Item Name: Crosstube Turning Detail

DART AEROSPACE LTD		Work Order: 74598
Description: Crosstube Assembly (205/212 Low Aft)		Part Number: D212-664-247
Inspection Dwg: D212-664-247 Rev: B		Page 1 of 1

DRAWING NO. D212-664-247	TITLE CROSSTUBE ASS'Y (205 LOW AFT)	REV. B	DART AEROSPACE LTD ENGINEERING ORDER		D.E.O. NO. D212-664-247-B-1	SHEET NO. SHEET 1 OF 1	SCALE NTS
DRAWN <i>q</i>	CHECKED <i>ASS</i>	MFG. APPR. <i>AB</i>	APPROVED <i>WD</i>		DE APPR. <i>AB</i>		
DATE 11.07.15	DATE 11.07.20	DATE 11.07.21	DATE 11/07/21		DATE 11.07.21

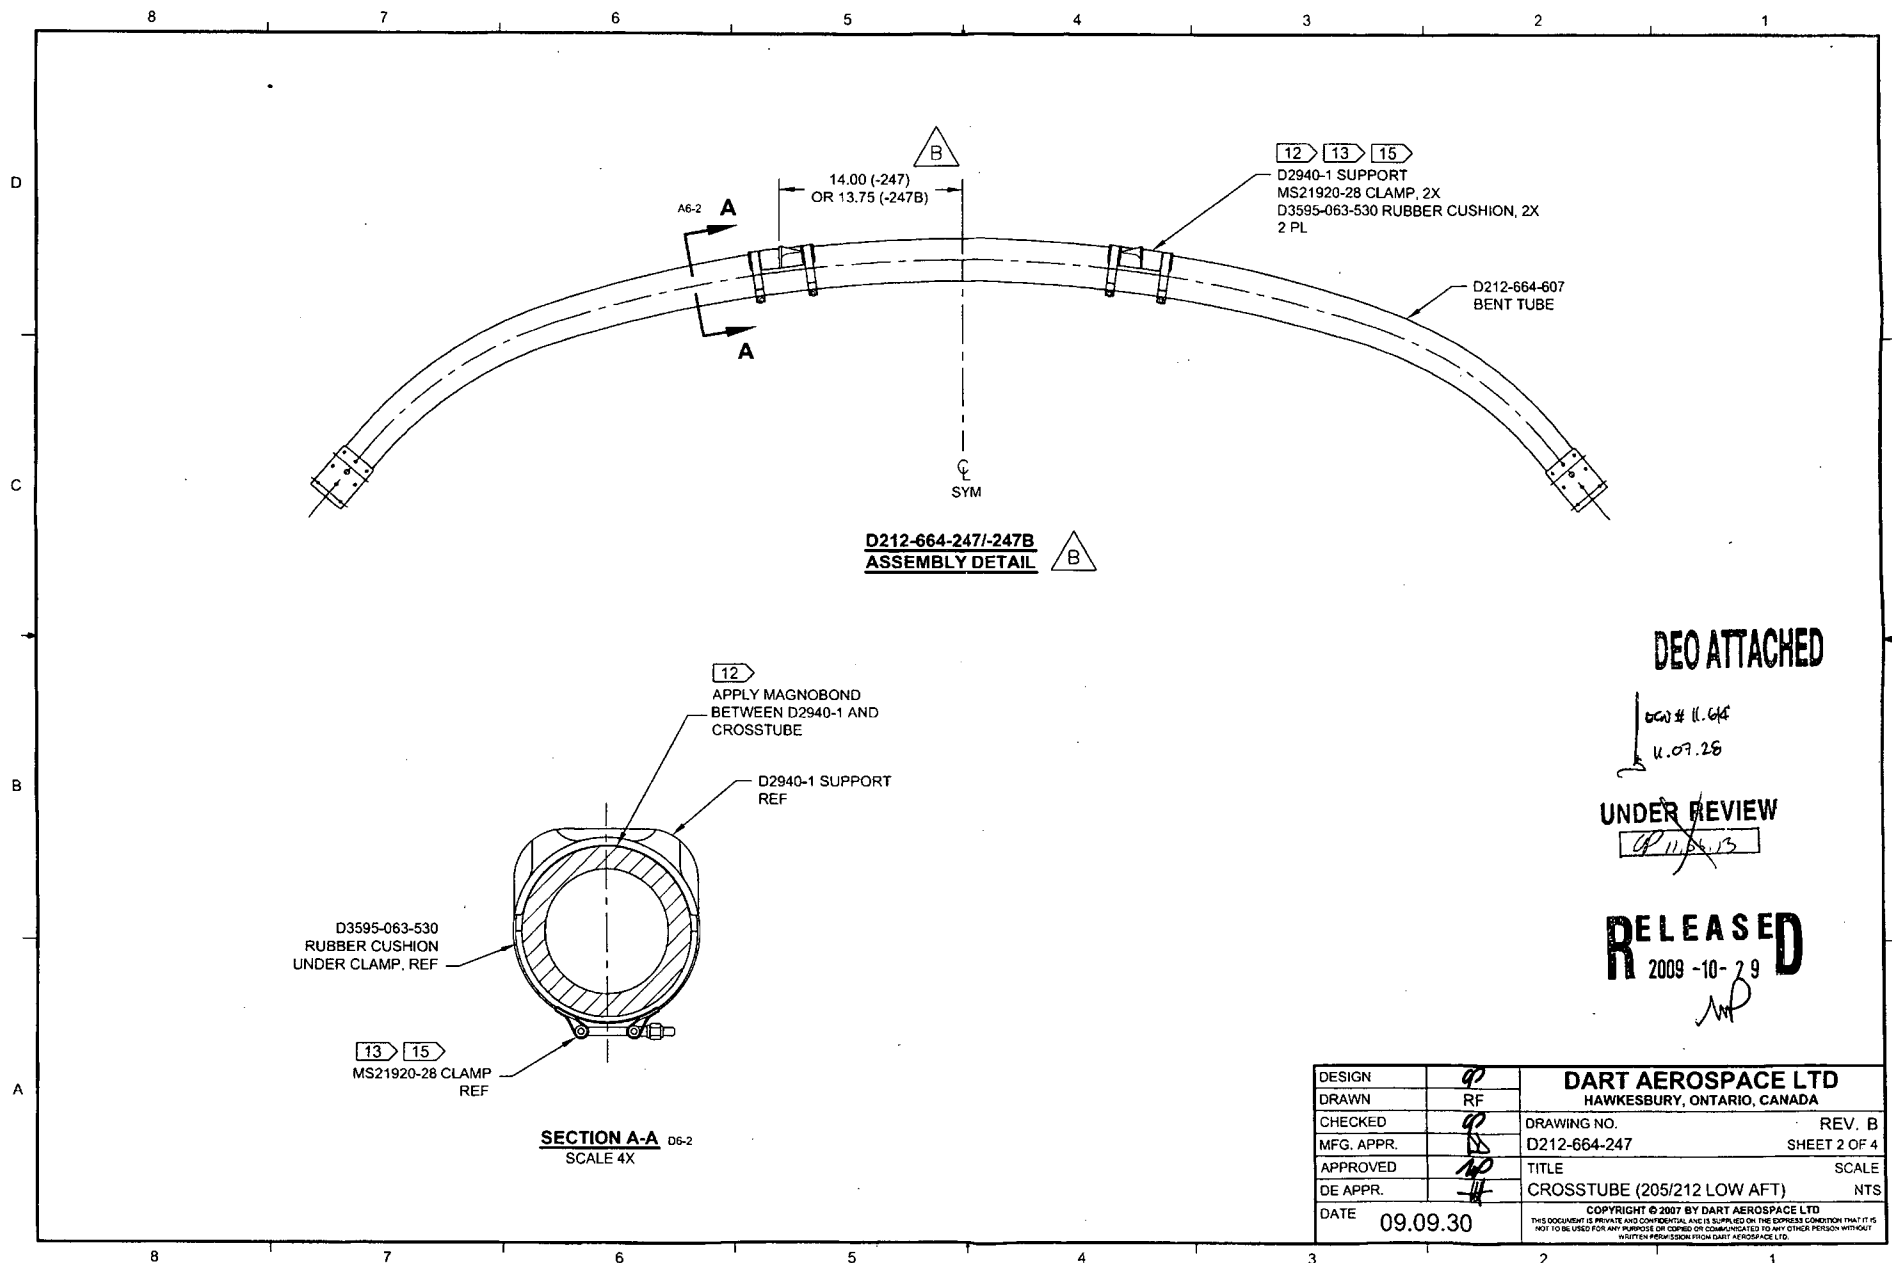
PURPOSE:

REPLACE MAGNOBOND WITH PROSEAL.

NOTE 12 & 15, SHEET 1 IS AMENDED AS FOLLOWS:

Item	Qty -247	Qty -247B	Part Number	Description
9	A/R	A/R	PROSEAL 890 B-2	SEALANT, AMS-S-8802 CLASS B-2

12) TO INSTALL D2940-1 SUPPORT: ABRASE MATING SURFACE OF SUPPORT AND CROSSTUBE WITH 180-GRIT SANDPAPER AND REMOVE RESIDUE WITH MEK (OR EQUIVALENT). APPLY A 0.04" TO 0.07" THICK LAYER OF PROSEAL 890 CLASS B-2 (OR AMS-S-8802 CLASS B-2) SEALANT TO MATING SURFACE OF SUPPORT.

15) TORQUE CLAMPS 80 TO 100 IN-LB. ENSURE AT LEAST 1.5 THREADS SHOWING IN SAFETY AND THAT NUT HAS NOT BOTTOMED-OUT AFTER TORQUING. **PRIOR TO PACKAGING, RE-CHECK TORQUE ON CLAMPS AFTER PROSEAL 890 SEALANT HAS CURED FOR 72 HOURS.**
